1993 Corvette: Service Bulletin: Hood Will Not Open - Cable Disconnection

Subject: HOOD WILL NOT OPEN, CABLE DISCONNECTED

Bulletin Number: 93-151-10

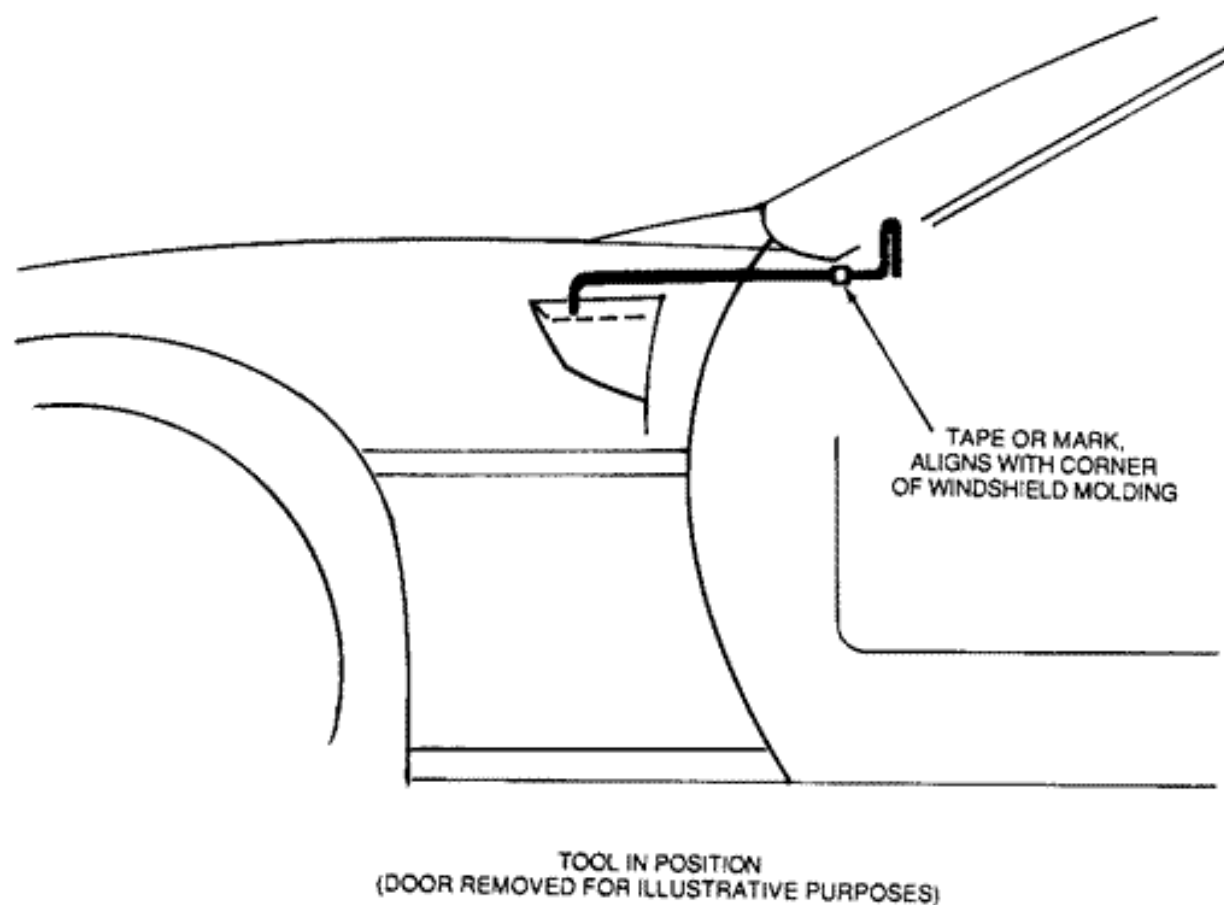
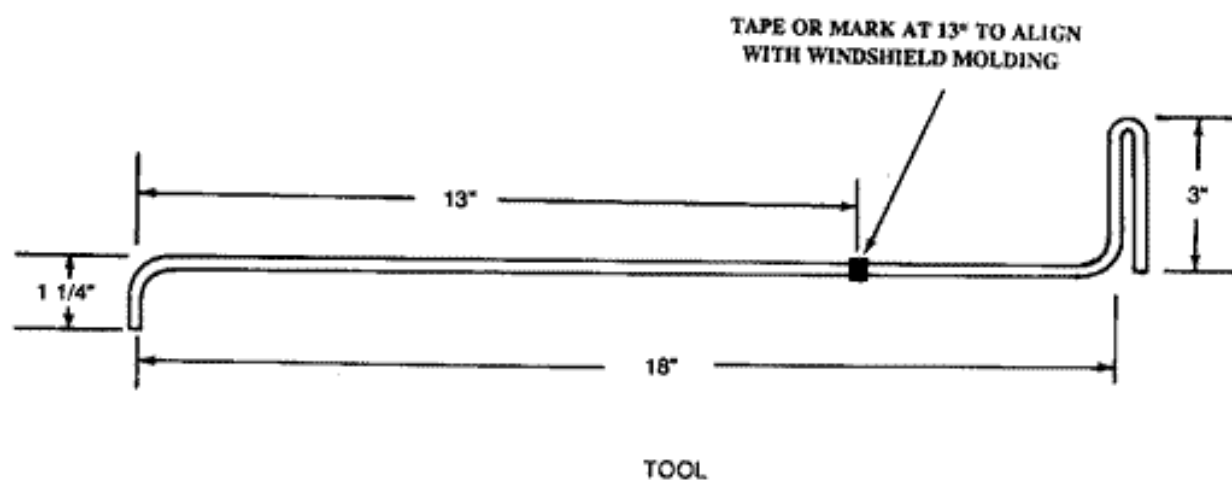
The hood release cable may become disengaged from the hood latch lever.

NOTE: It is possible that one or both of the latches may have disengaged cables.

NOTE: Opening the hood will require the following:

- Obtain material locally and fabricate the tool shown on the illustration from 3/16" or 1/4" steel rod.
- With the door open, locate the short bent end of the tool inboard of the vertical flange of the hood latch support.
- Insert the tool forward until the tape is aligned with the lower end of the windshield pillar molding.
- Twist the tool to contact and move the latch lever until the latch disengages. A slight downward pressure on the hood in the latch area may be helpful to disengage the latch lever.

Replace the hood latches with service P/N's 10210747 (Left) and 10210748 (Right)
